Nottinghamshire County Council

Local Impact Report – Steeple Renewable Project

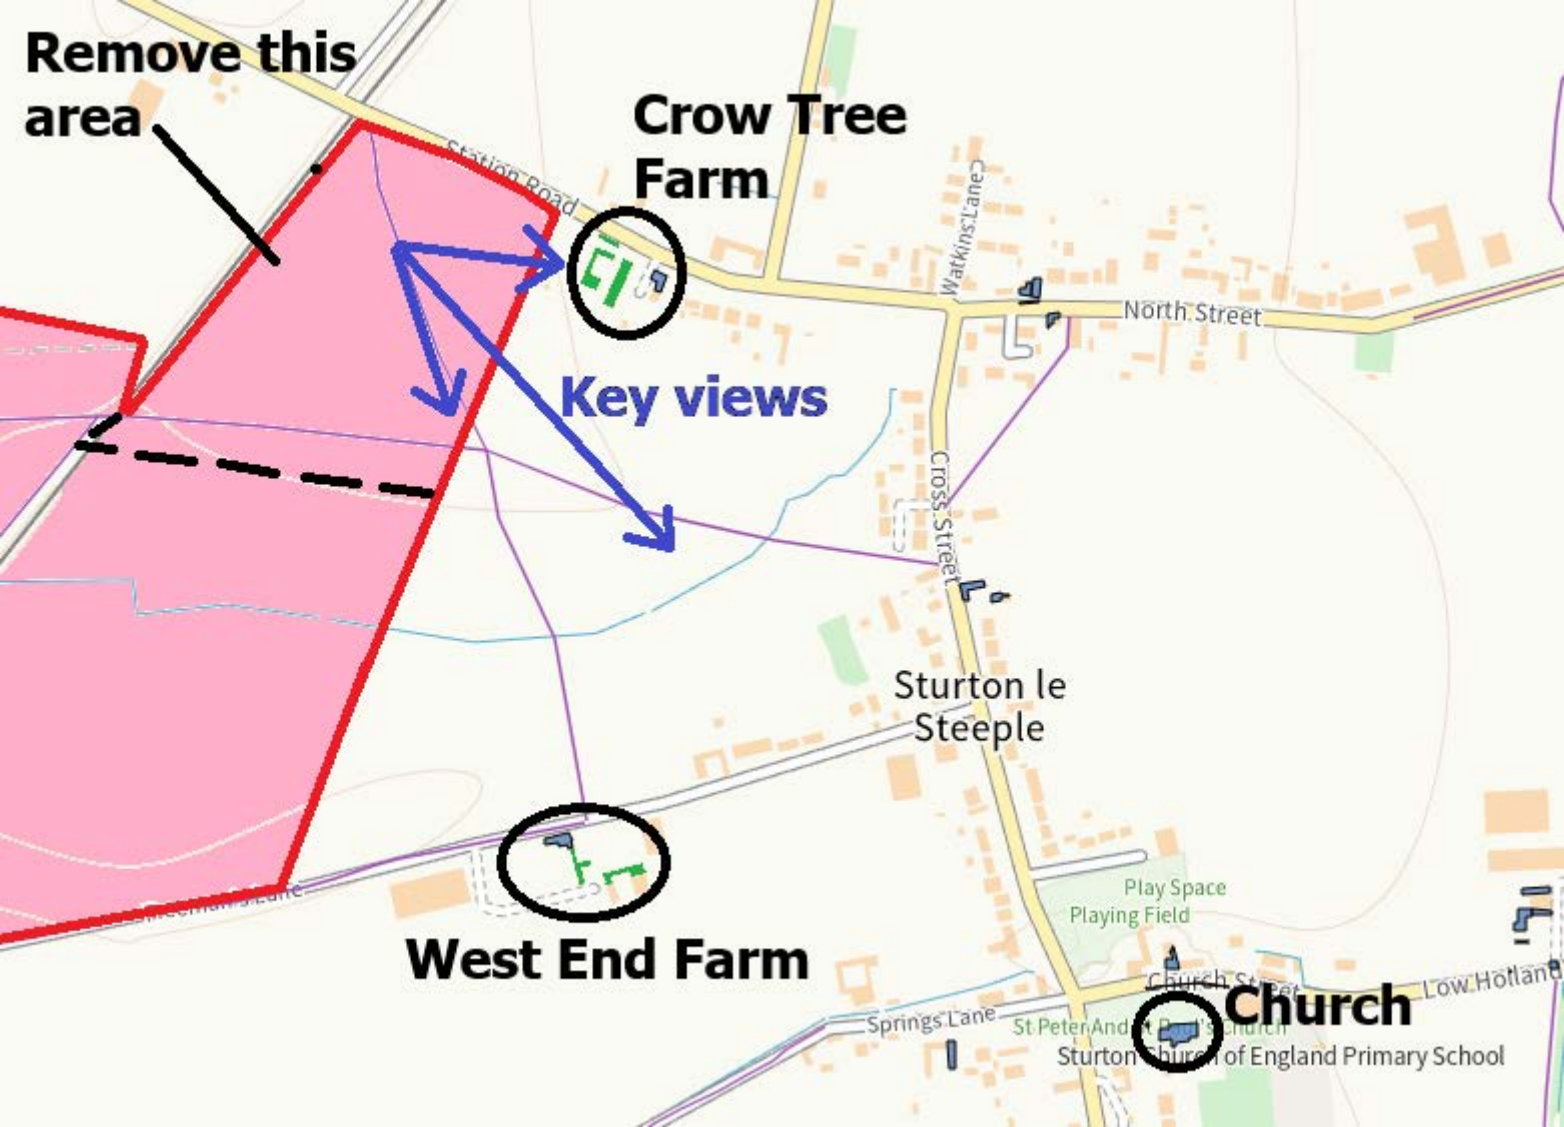
Remove this area

Plate 8.3 – Forecast Workforce Traffic Peak Trip Generation at Bawtry Signal Junction

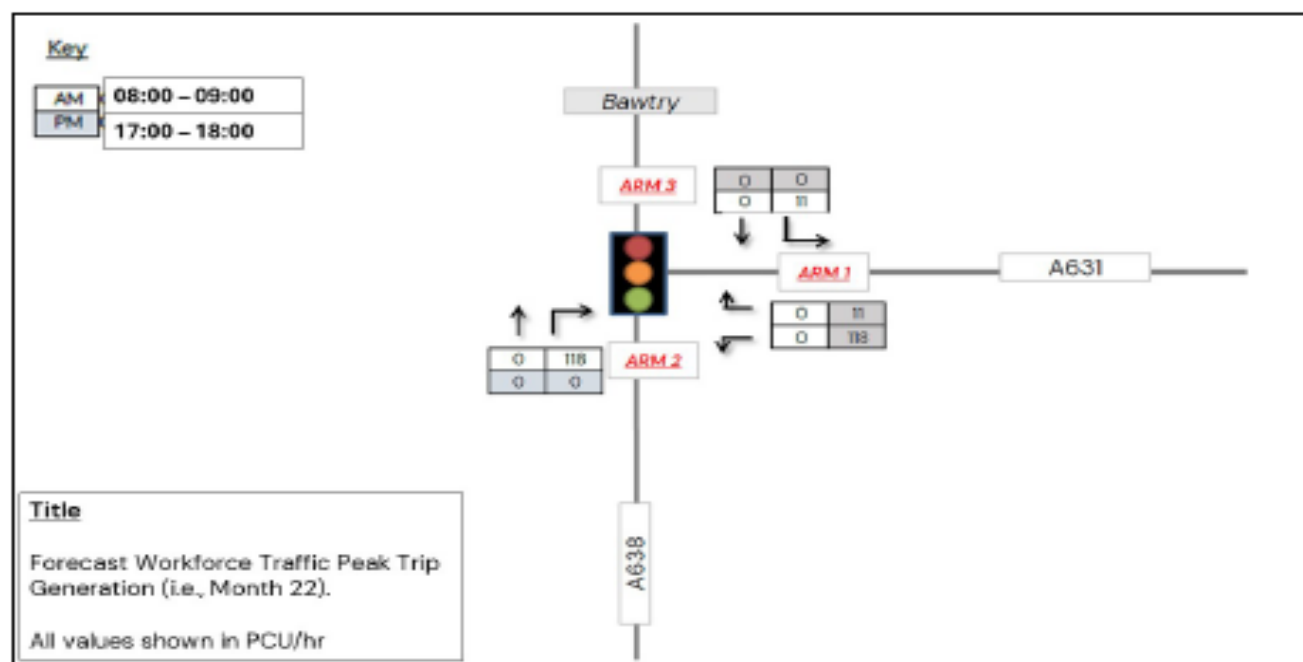
- **2025 base DM + DS Forecast: Month 22 129 PCU**
 - **AM Peak: +7% overall traffic increase but +18% A638 S**
 - **PM Peak: +7% traffic increase but largest impact arm +29% A631**
- **Similar for 2029 future year DM & DS**
- **Mitigation: No further junction capacity assessment needed due to temporary nature and OCTMP measures.**
- **Plate 8.6 85% change in flow AM A638 to site, 91% from site - Is this because baseline flows are low?**
